City of San Antonio
Development Services Department

Re: **Steubing Ranch – Major Amendment**

MDP # 025B-08

STEUBING RANCH
651.30 ACRE TRACT
MASTER DEVELOPMENT PLAN
MAJOR AMENDMENT

SHEET C100

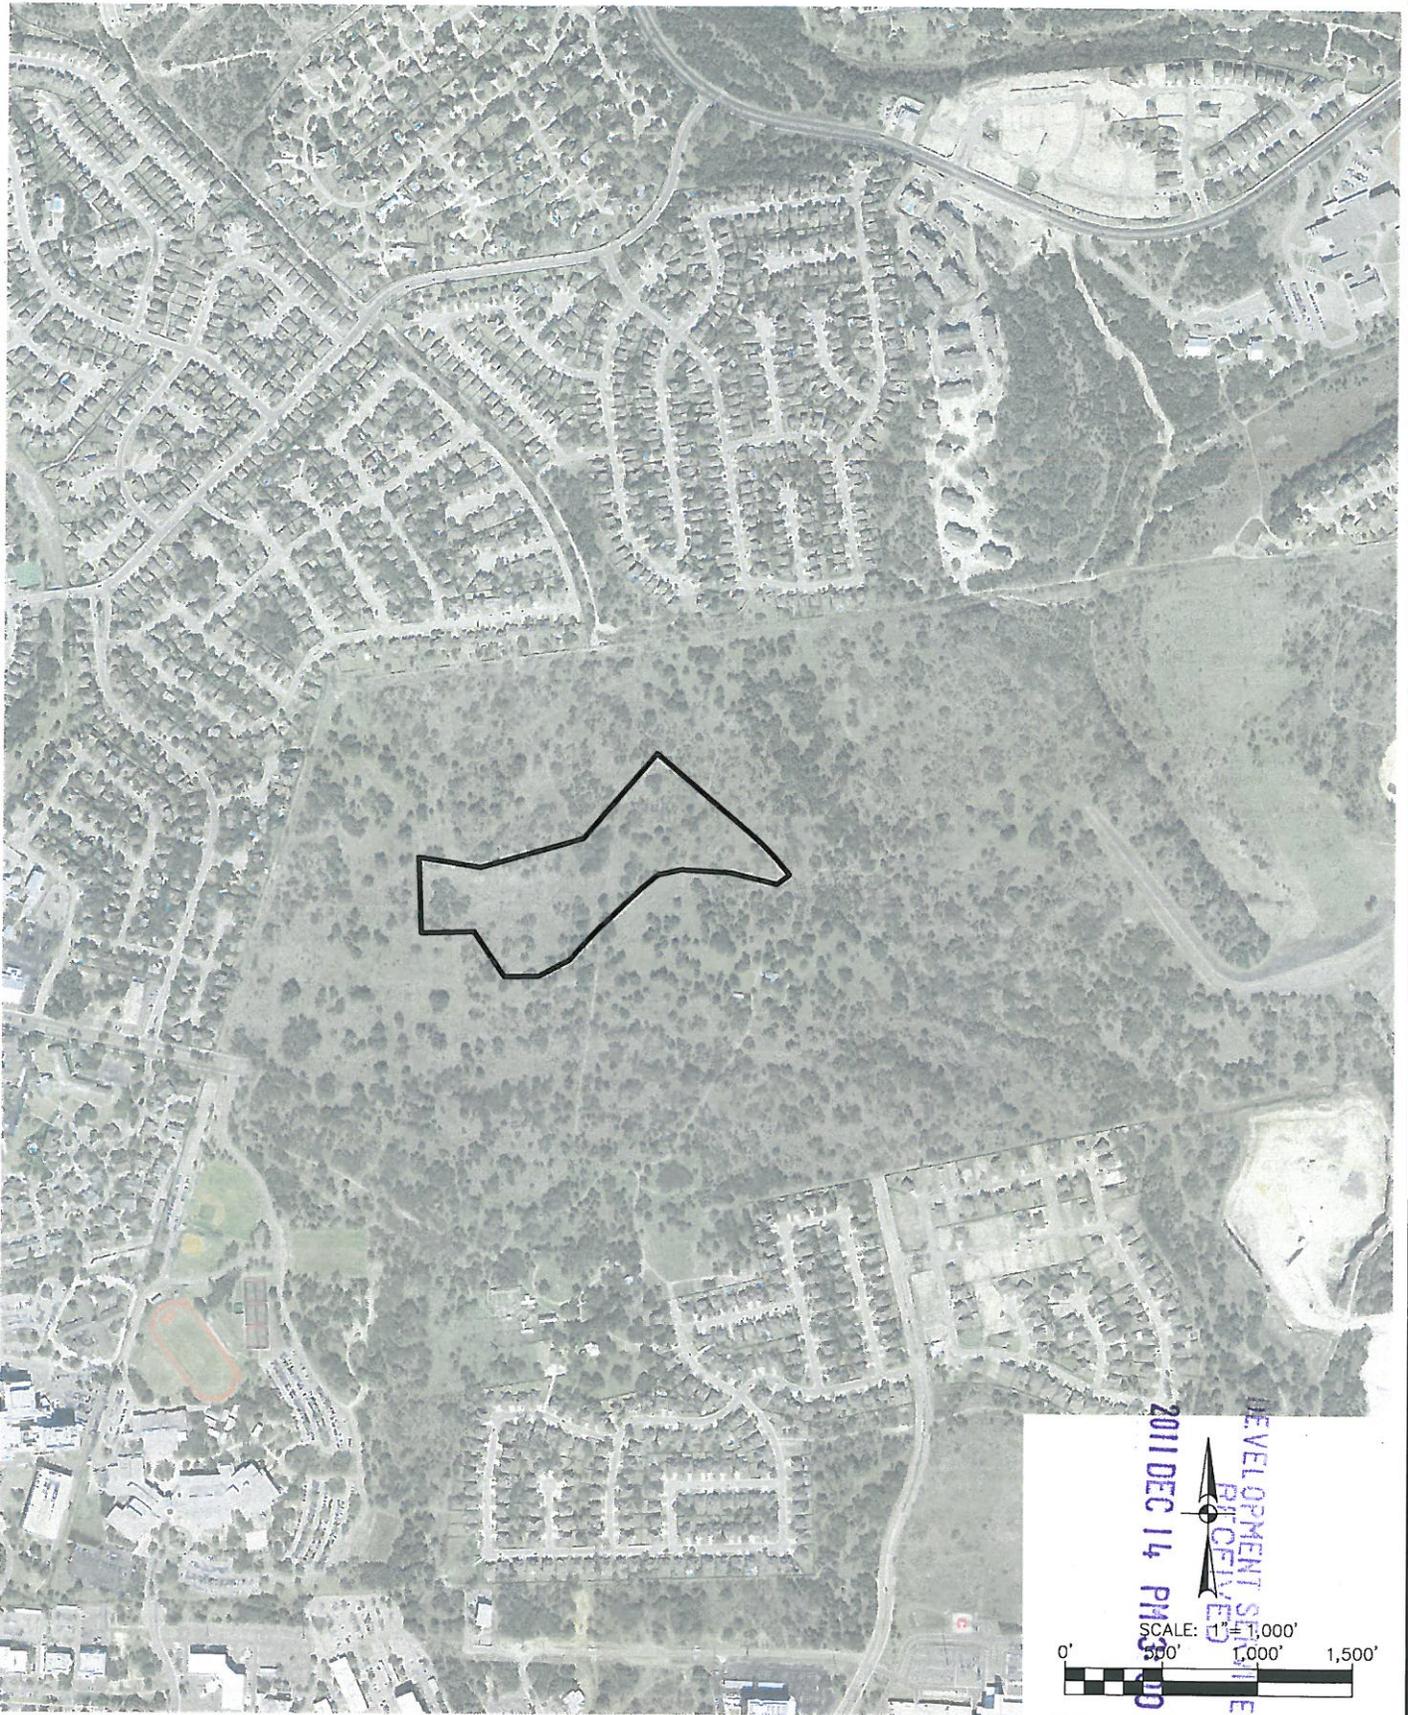
The Development Review Committee has evaluated **Steubing Ranch** Master Development Plan, Major Amendment or **MDP # 024B-08**. Enclosed is an accepted and signed copy of the MDP for your files. However, please note the following conditions:

It will be expected that all of the property depicted in the Master Development Plan including but not limited to floodplains, drainage areas, and open space shall be platted. All platting shall comply with the Unified Development Code (UDC), the City's Master Plan, Major Thoroughfare Plan, and all applicable regulations for the City of San Antonio.

Please note that this action by the committee does not establish any commitment or support for the provision of drainage, utilities services, or zoning of any type now or in the future by the City of San Antonio. In addition, it is suggested to work closely with the School District, so they can plan for the development accordingly.
